Team Update 05

Figure 2-1: FIRST STEAMWORKS playing area

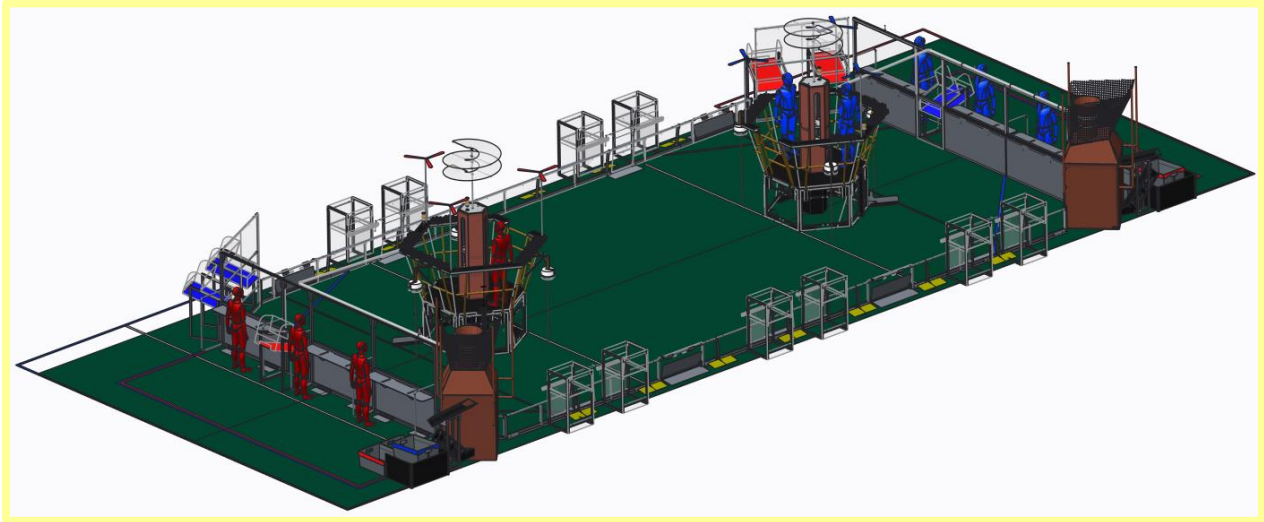
Figure 2-1, a still from the [2017 FIRST STEAMWORKS game animation](#), has been replaced with an export from the official CAD model of the *FIRST STEAMWORKS* playing area per the first bullet in General Notes above.
